Proposal for draft amendments to Regulation No. 117 (Tyre rolling noise, wet grip adhesion and rolling resistance)

The text reproduced below was prepared by the experts from the Russian Federation. This proposal concerns existing methods of tyre rolling resistance determining.

Figure 1. Tyre 225/70 R15C skim reading resistance(F_{p sk}) in comparison with drum parasitic losses (F_{pD}) when tyre removed.

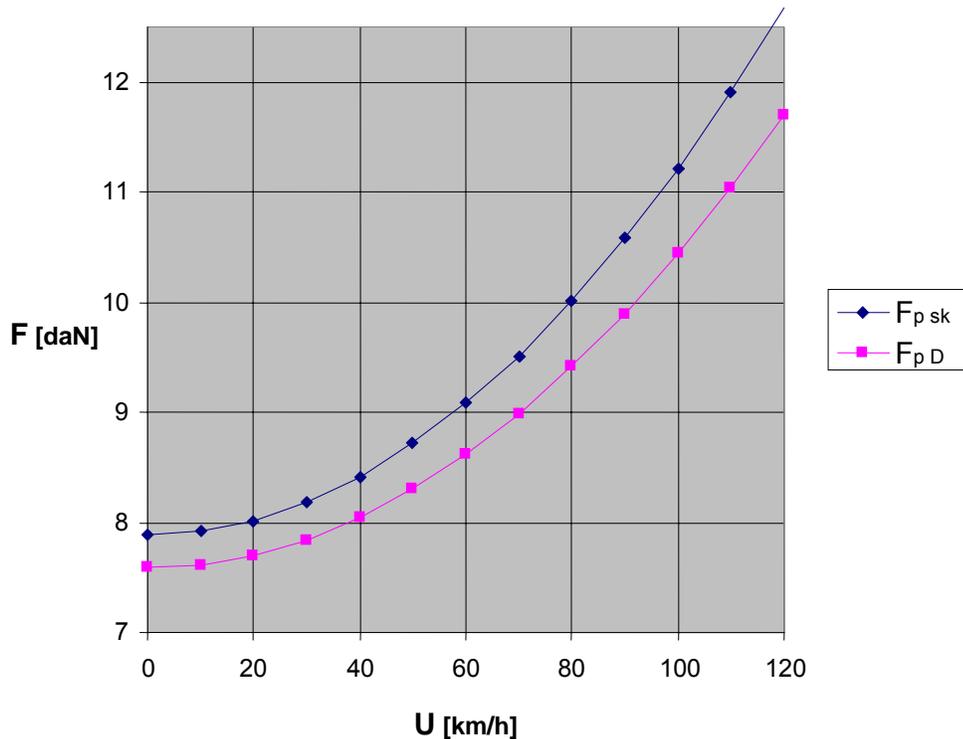
The paragraph 4.6.1 as well as paragraph 7.6.2 in ISO 28580 regulates two times increased norms of skim test load values without any information about experimental confirmation of such action correctness. Skim test load increasing is aimed to artificial rise of tyre parasitic losses and consequent understating of rolling resistance (RR) coefficient. In supposition that C_r during skim test is the same as at RR test the next examples show the effect.

J1269 and J2452 regulate skim test load on the levels of 100,150 and 220 N for PC, CV and TB tyres correspondently. Twice increased skim test load norms introduced into Regulation No.117 are not validated and may be considered as aimed on tyre rolling resistance understating, being in conflict with the paragraph 2.17.10 (“energy loss within the tyre itself is virtually zero”).

- (i) Class C1 tyres: recommended value of **not to exceed 100 N**; ~~not to exceed 200 N~~;
- (ii) Class C2 tyres: recommended value of **not to exceed 150 N**; ~~not to exceed 200 N for machines designed for Class C1 tyre measurement or 500 N for machine designed for Class C2 and C3 tyres~~;
- (iii) Class C3 tyres: recommended value of **not to exceed 220 N** ~~400 N; not to exceed 500 N.~~"
